TITLE	Preamp daughter board, kinabalu project	
FILE:		REVISION:
PAGE	OF	DRAWN BY:

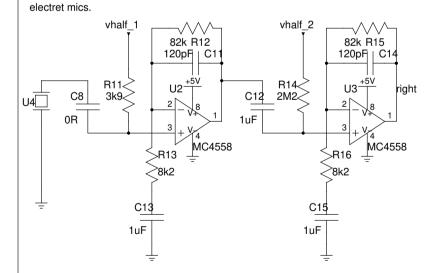
values for bias and gain components must change. Values shown are for

PCM1808 inputs have own bias, and output caps not required.
